A REVIEW OF THE OCONEE-3 PROBABILISTIC RISK ASSESSMENT:
INTERNAL EVENTS, CORE DAMAGE FREQUENCY

N. A. HANAN, D. ILBERG, D. XUE, R. G. FITZPATRICK, T. L. CHU

DEPARTMENT OF NUCLEAR ENERGY
BROOKHAVEN NATIONAL LABORATORY
UPTON, NEW YORK 11973

AUGUST 1985

Figure 3.1 Event Tree for Transient Initiating Events

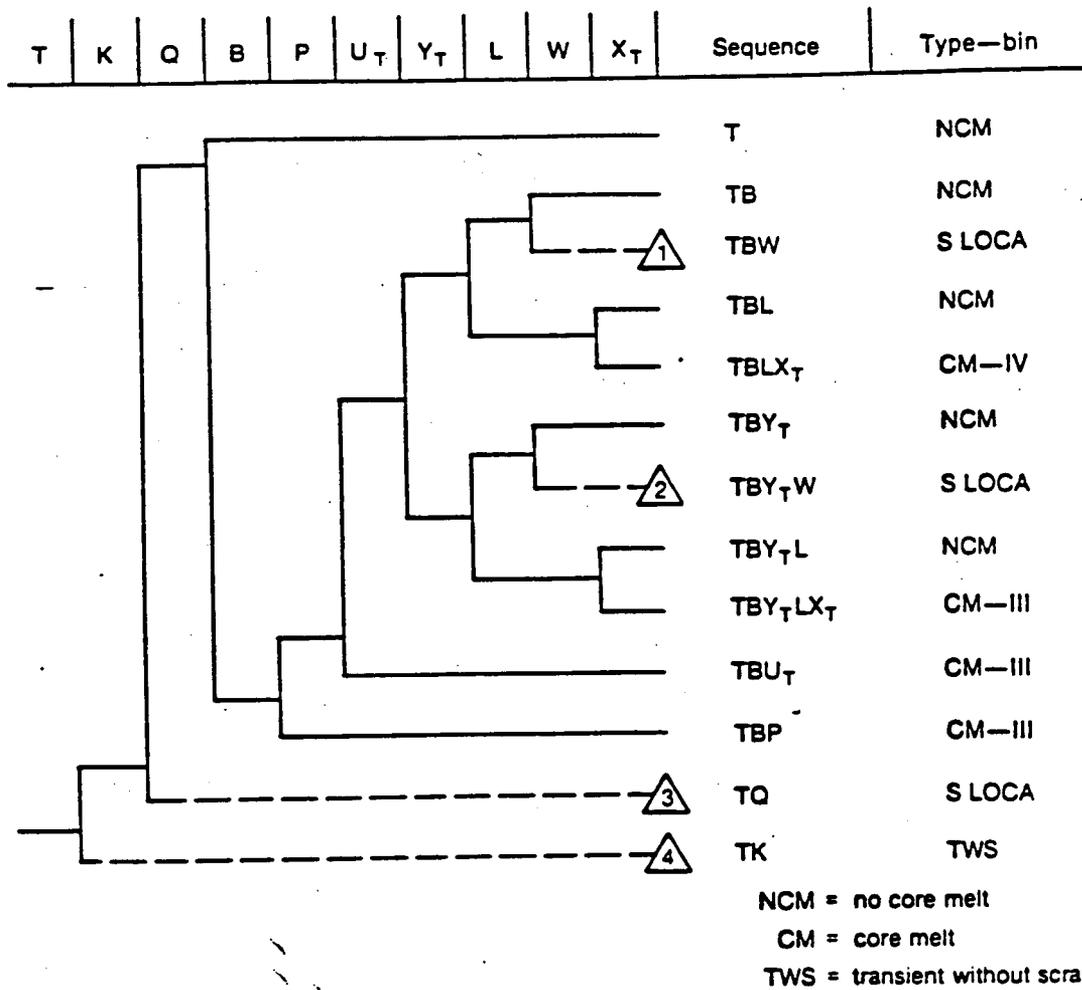
The transient event tree is modeled using the functional event tree given in Fig. 3.1, and the function-oriented top events are listed in Table 3.1. The supporting logic for the top events in the functional event-tree is given in Figures 3.2 through 3.8. Again, it should be emphasized that very few differences exist between this review and the OPRA; so Figures 3.2 through 3.8 in this report are almost reproductions of Figures 3.5 through 3.11 in the OPRA. Some modifications in event names were made because the OPRA uses what is called the modularized system fault-trees, and this review uses the detailed fault-trees.

The first top event evaluates the question of successful scram (K). For the case where the scram is not successful the sequences are transferred to the ATWS event-trees (see Section 3.1.6). Otherwise, the evaluation of the function Q, loss of RCS integrity, follows.

In conclusion, BNL's review of the OPRA functional event tree for transients found that it correctly represents a detailed qualitative model of the plant response.

Figure 3.2 Supporting Logic for Transient Event Tree Top Event Q, Failure of RCS Integrity

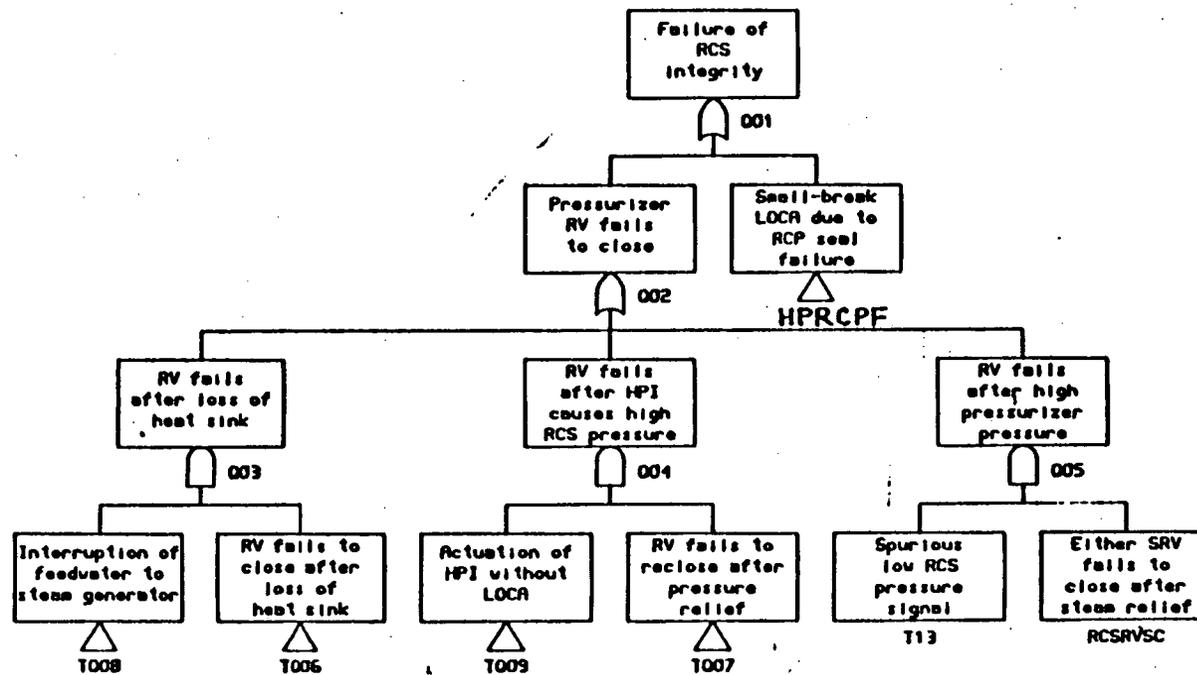
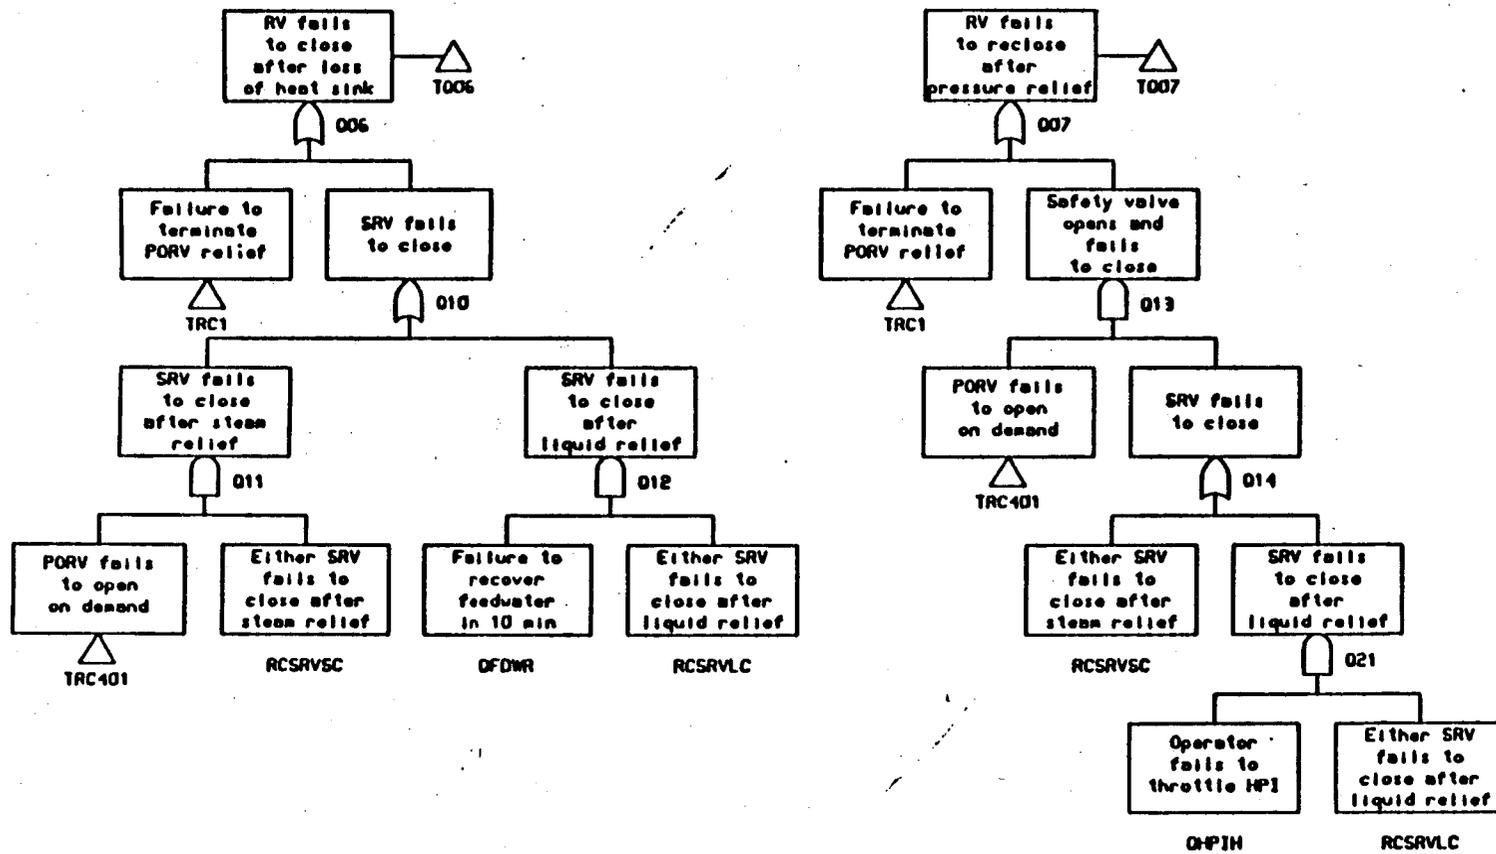
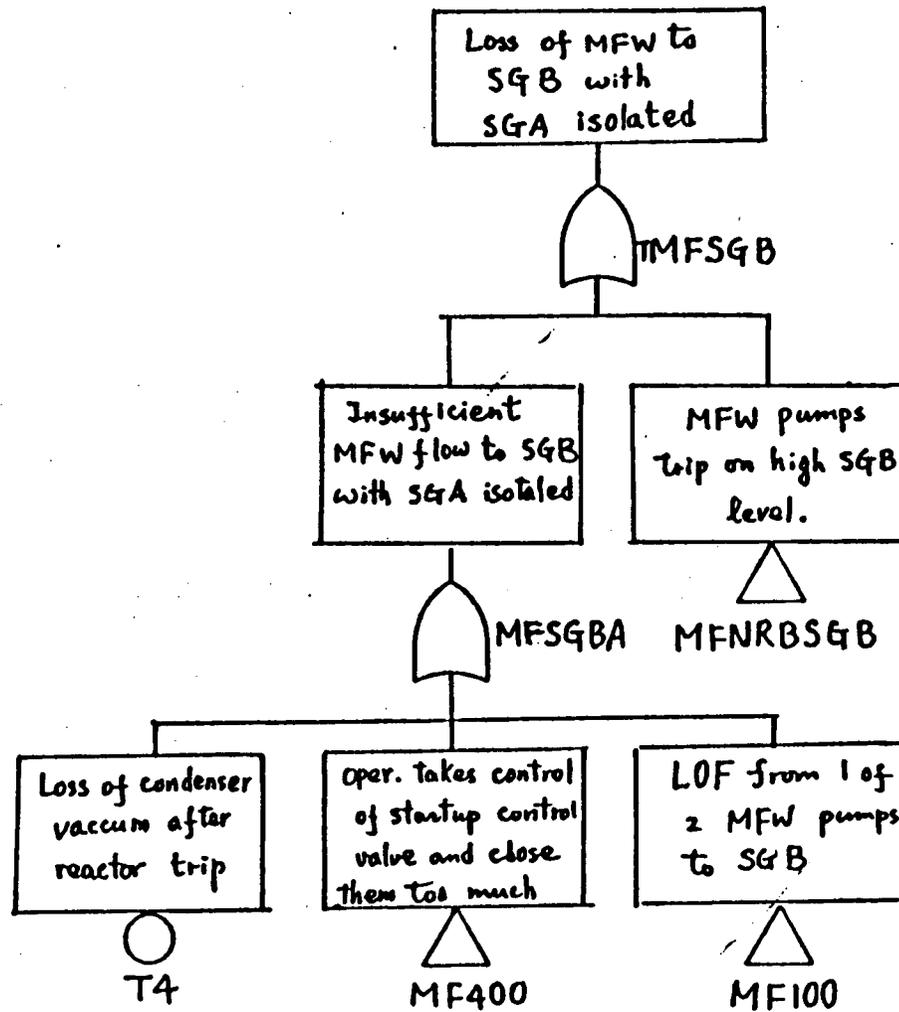
Supporting logic for function Q (Figure 3.2) is developed to evaluate the different possibilities that could result in a stuck-open pressurizer PORV or SRV (gate 002), or that could lead to a failure of the RCP seals (gate HPRCPF, transferred from the HPI system fault trees). The analysis of the progression of the transient accident sequences with failure of the RCS integrity, Q, is transferred to the event tree for small-break LOCAs (Figure 3.9).
